**TOWN OF PORTOLA VALLEY
ARCHITECTURAL AND SITE CONTROL COMMISSION (ASCC)
Wednesday, May 29, 2013
Special Joint Field Meeting (time and place as listed herein)
7:30 PM – Special ASCC Meeting
Historic Schoolhouse
765 Portola Road, Portola Valley, CA 94028**

4. Old Business:
 - a. Continuing Review, Architectural Review and Site Development Permit X9H-653 for Residential Redevelopment, 308 Canyon Drive, Lenderking
5. New Business:
 - a. Preliminary Architectural Review for New Residence with Detached Garage/Guest House Accessory Structure and Horse-Keeping Facilities, and Site Development Permit X9H-652, 25 Larguita Lane, Shostak
 - b. Architectural Review for Residential Additions and Remodeling, 140 Corte Madera Road, Lee
6.
 - a. Review of Draft Portola Road Corridor Plan
 - b. Commission and Staff Reports
7. Approval of Minutes: May 13, 2013
8. Adjournment

TO: ASCC
FROM: Tom Vlastic, Town Planner
DATE: May 29, 2013
RE: Agenda for May 29, 2013 Special ASCC Meeting (*Rescheduling of regular May 27, 2013 ASCC meeting which falls on Memorial Day.*)

Scale: 1/4" = 1'
May 20, 2013
New Floor Plan
Page A-2

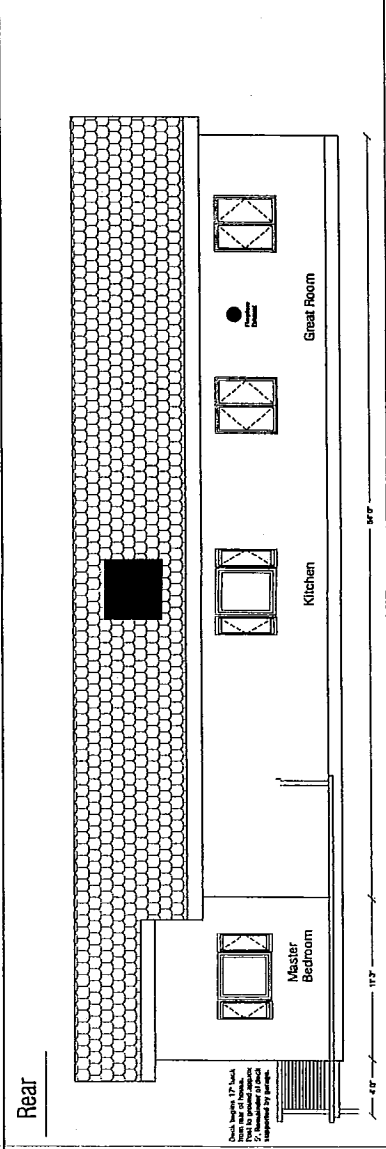
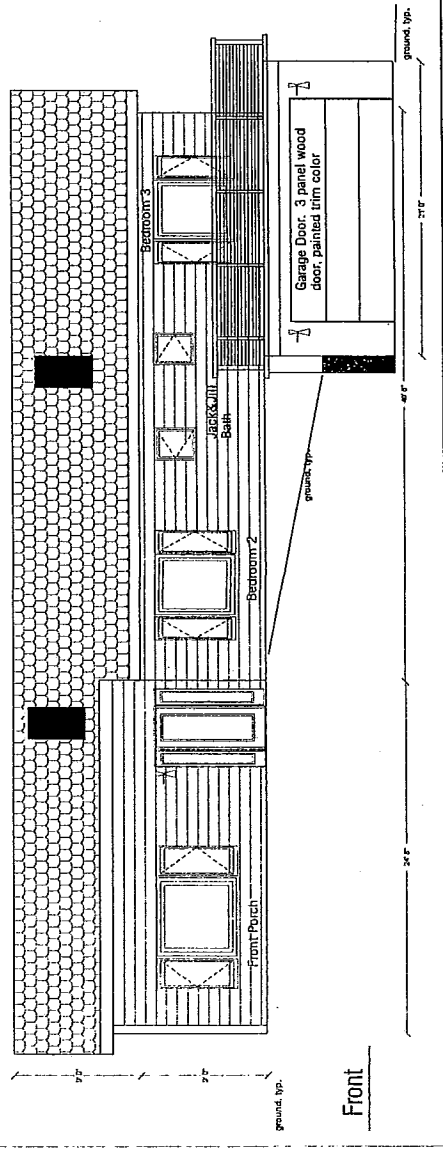
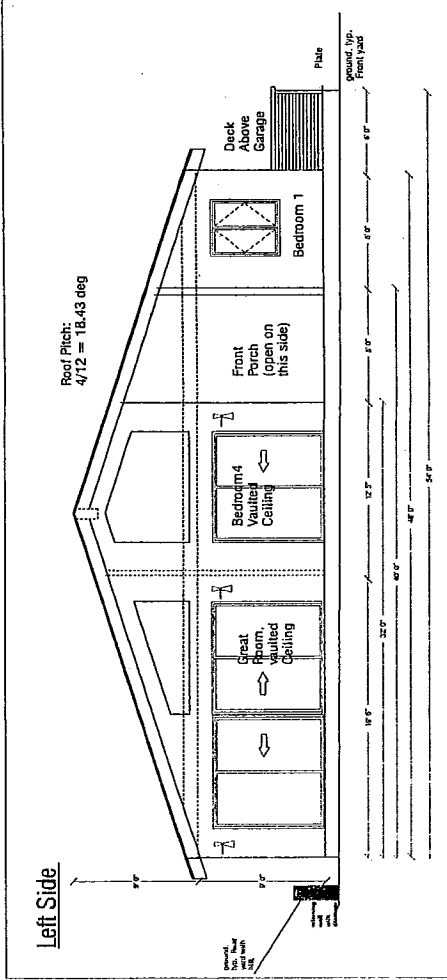
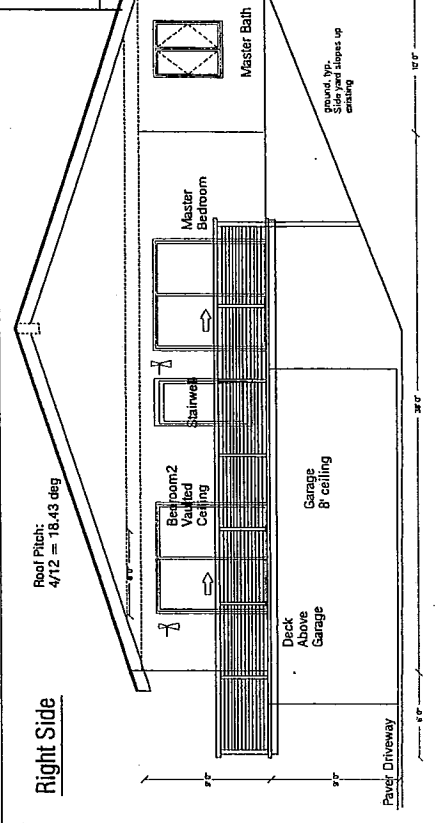
The driveway plans have been modified, with wider transition to Canyon Drive, for improved egress and ingress (Sheet 1 of the engineering plans and notes on Page A-4.). Also, the great room skylights have been removed with only one skylight in the rear kitchen area (Page A-2). The two front elevation hallway skylights have been retained. The reflected ceiling plans show that the ceiling height in the hallway would be nine feet.

- Deleted 2 front light fixtures.
- Deleted 5 of 6 skylights in great room. Reamaining one increased to 4'x4'.
- Show Stainless steel posts. Material brushed natural stainless steel.
- Top cap of railing to be same material as deck (1x6)

Scale:
Not to Scale
5/20/2013
Landscape Plan
Story Pole Plan
Page A-4

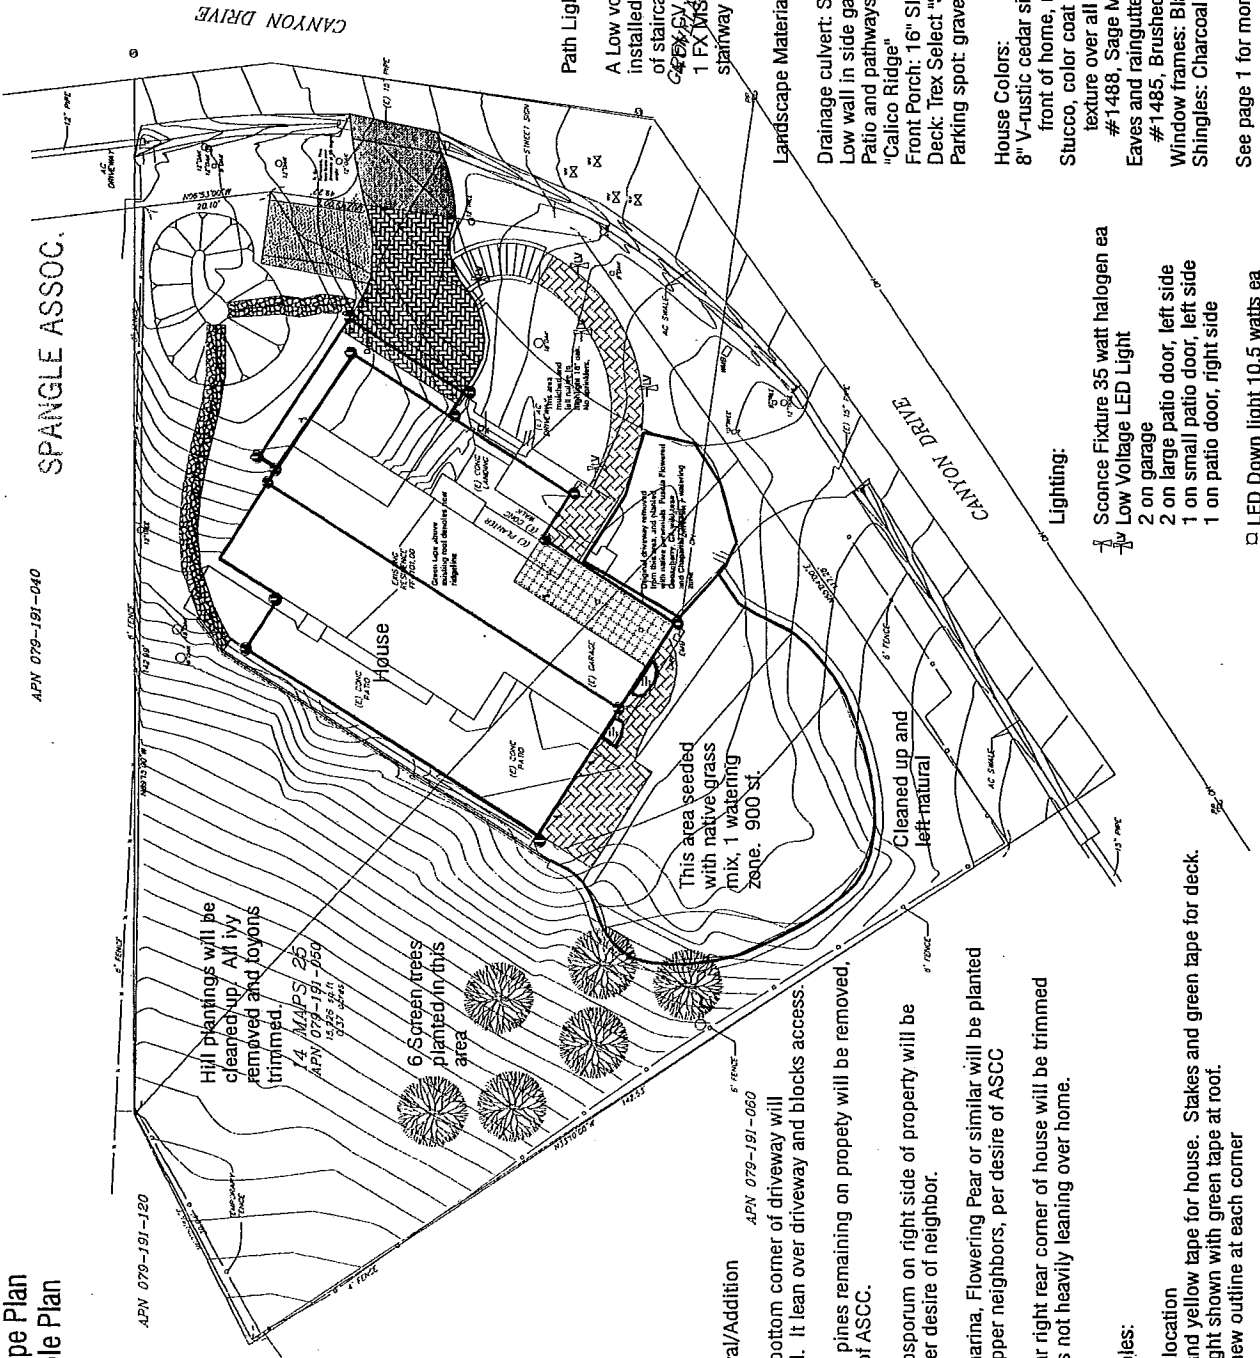
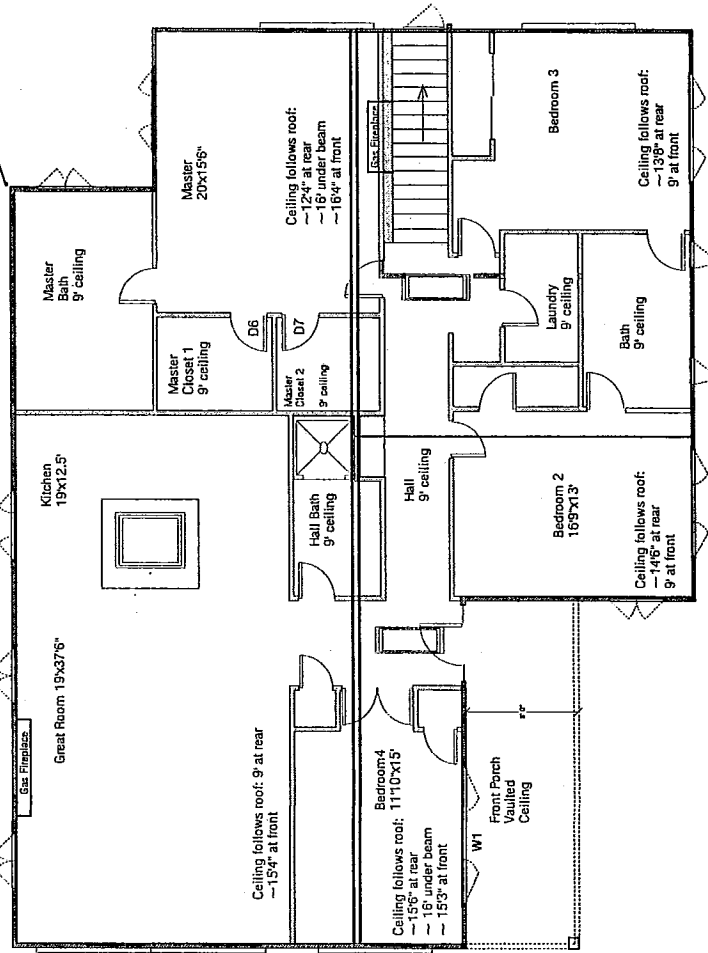
2. **Landscaping.** The concepts for landscaping on Page A-4 are consistent with ASCC directions. Prior to building permit sign off, however, a detailed landscape plan should be provided to the satisfaction of a designated ASCC member calling out specific trees and shrubs by type and size. Also, there should be an ASCC member inspection relative to final tree locations, and tree size should be adequate

3. **Exterior lighting.** The plans as modified appear to be consistent with ASCC directions. See Page S-4 and attached cut sheets and, particularly, the notes on Page A-4.

4. **Construction staging.** While the engineering plan sheets and Page A-4 provide some construction staging data, a detailed plan will be needed with the building permit submittal to address all of the concerns noted in the preliminary review comments. This plan should be to the satisfaction of staff and a designated ASCC member.

Construction Staging Plan:
See Civil plans. Increase Upper and lower culvert length to 28' each.
Fill new corners with crushed gravel. This will allow truck access to the property with no impact on neighbors.
At end of project, gravel at top culvert will be replaced with soil from site, and left to naturally replant.
The grass area will not be used as a construction materials holding area.
Culverts on Canyon are quite dangerous, so increasing covered culvert length permanently will effectively make the road safer for pedestrians and bicyclists.

Path Lighting:
A Low voltage path lighting system will be installed, with an outside switch near bottom of staircase, and an inside switch in entry hall. ~~Color~~ EV, natural copper, 3 LEDs ea (20 w. equiv) 1 FX MS, ~~Grassy~~, 1 LED (10 w. equiv), on wall of stairway over switch.

SITE PLAN

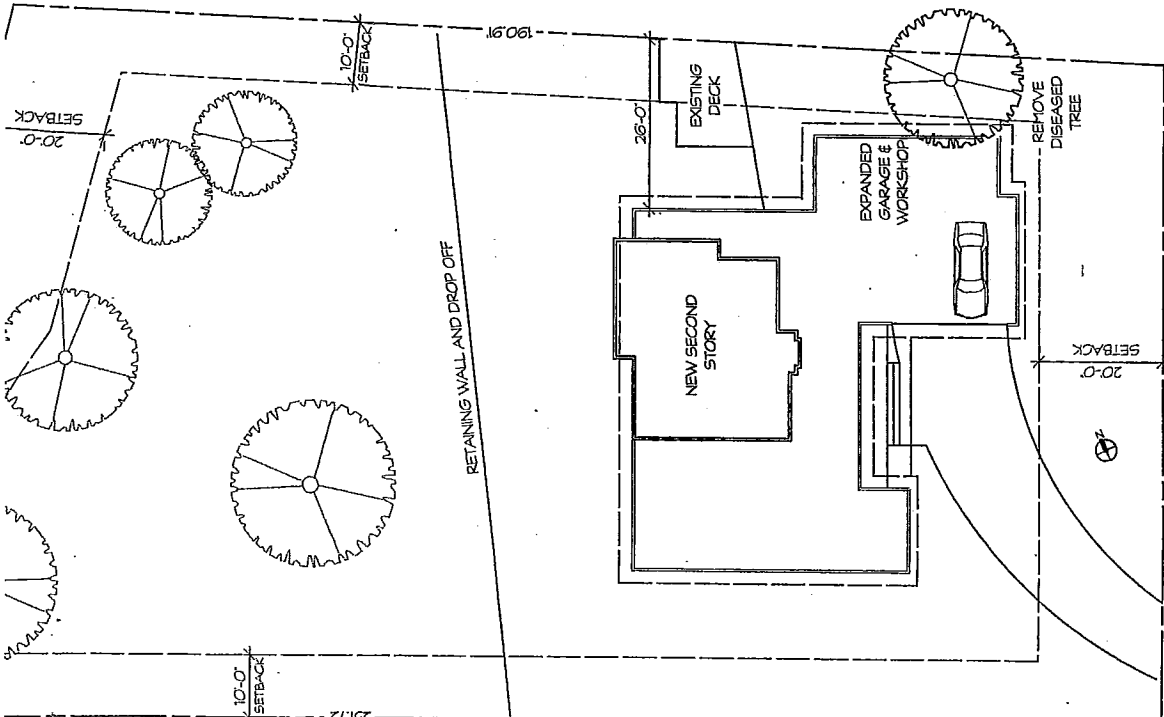
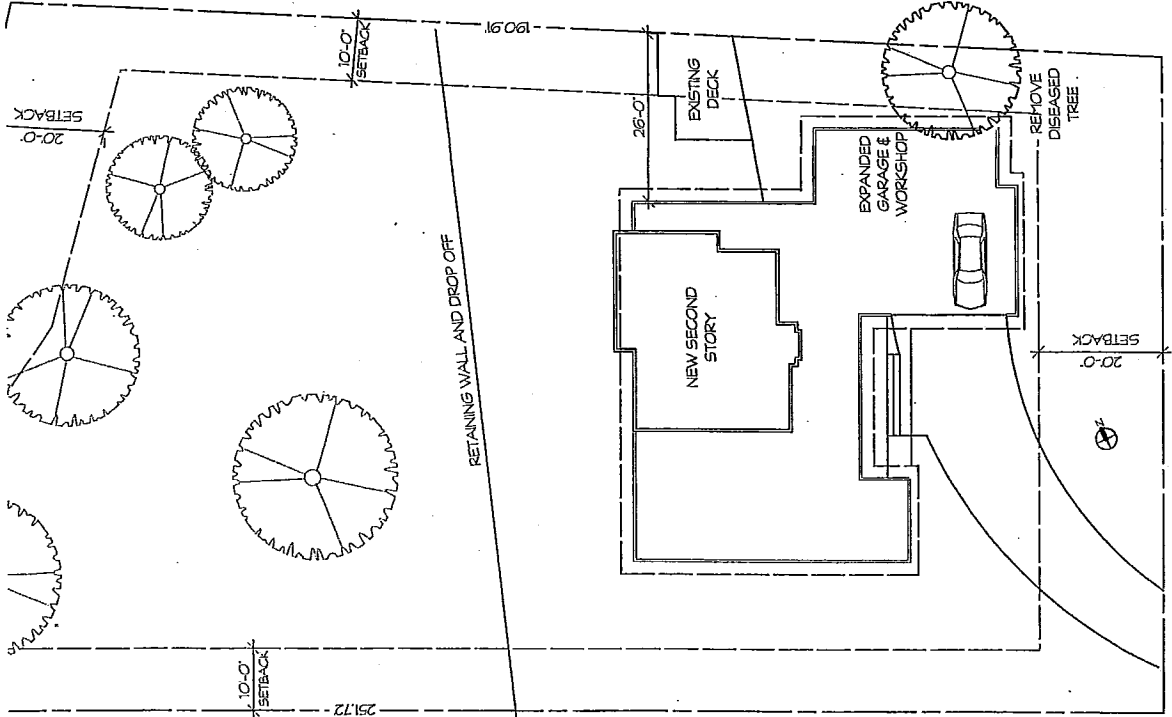
The proposal is to modify the garage space so that the vehicle doors would be accessed from the south side instead of the current east side. This eliminates direct view from the street to the garage doors and allows elimination of one of the driveway connections to the street. The plans are not clear, however, as to the scope of the front yard paving that is to be retained or if there will be pavement preserved to allow a vehicle to back out the garage and maneuver so that backing into the street can be avoided. A site plan that ensures this is possible should be provided.

The proposed changes to impervious surfaces (IS) and calculation to judge IS area compliance with town standards are not presented on the plans. It is clear that there will be a reduction in IS area but more data is needed and this should be based on a site plan that addresses the access issue discussed above.

Compliance with the required 20-foot front and rear yard setbacks and the 10-foot side yard setback is demonstrated on the site plan sheet. All setbacks are satisfied and setback averaging is not necessary for compliance.

FRONT ELEVATION

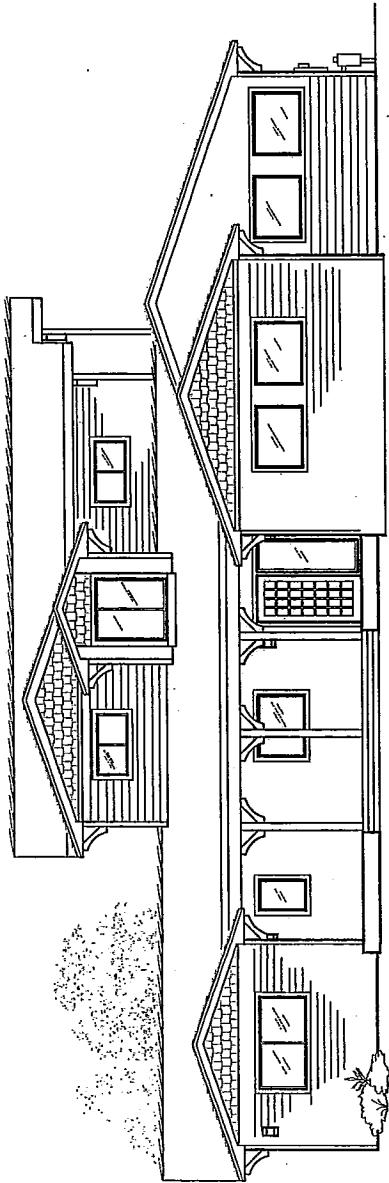
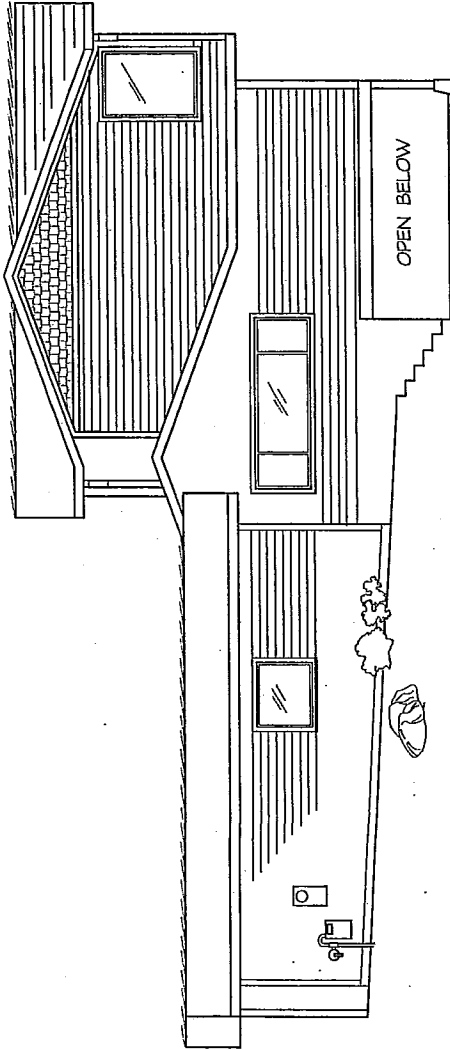
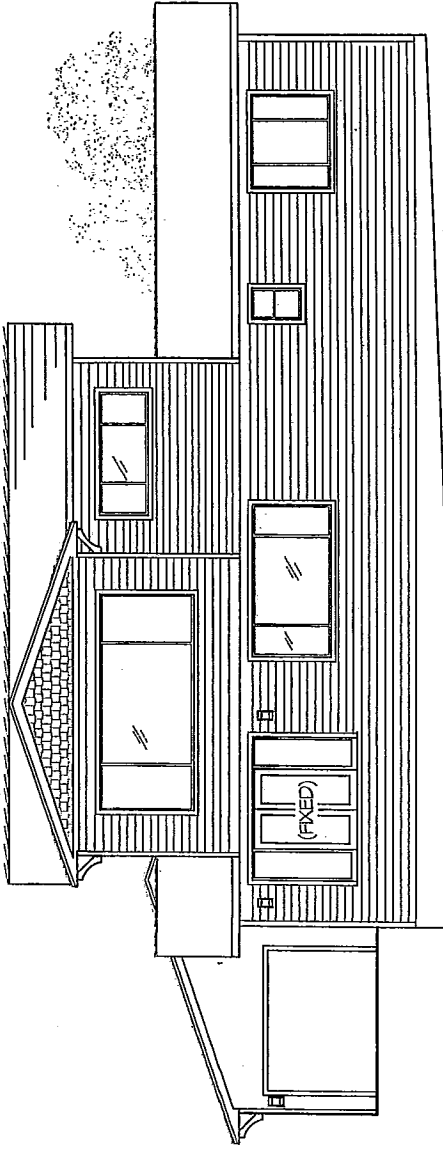
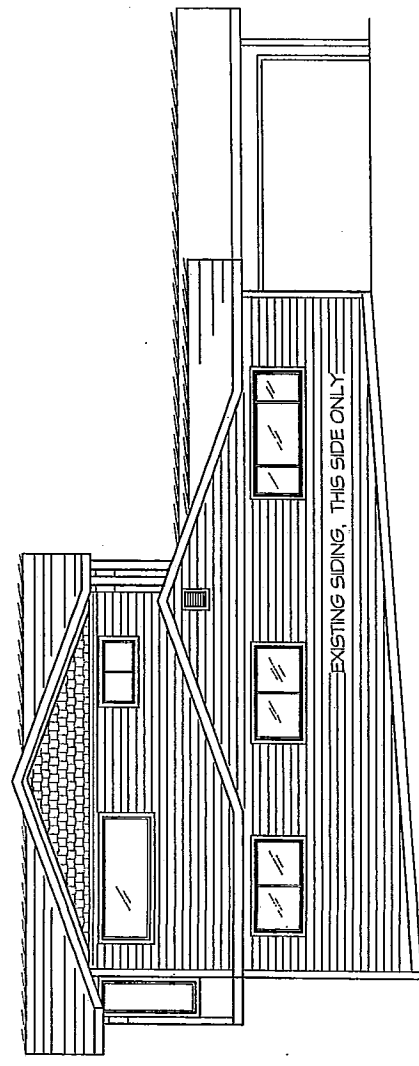
The maximum height of the proposed new ridgeline is at the second story addition, i.e., at the north side elevation, and scales at 28.5 feet. This is below the 34-foot maximum height limit, but six inches over the 28-foot limit for height above adjacent grade. Thus, the building permit plans would need to verify conformity to the 28-foot limit to the satisfaction of staff. Otherwise, all proposed heights are well under the ordinance limits.

6. **Exterior lighting.** Proposed house lighting appears to be shown on the plan elevation sheets, but we wonder if the plan is complete. We assume that lighting would be proposed at the new front of the garage but this is not shown. Of the lights shown on the elevation sheets at least three appear to be for access around the house. It is also noted that there is no access from the rear of the house to the rear yard, thus no door lighting would be needed to meet code standards. In any case, a complete lighting plan should be provided with the building permit submittal.
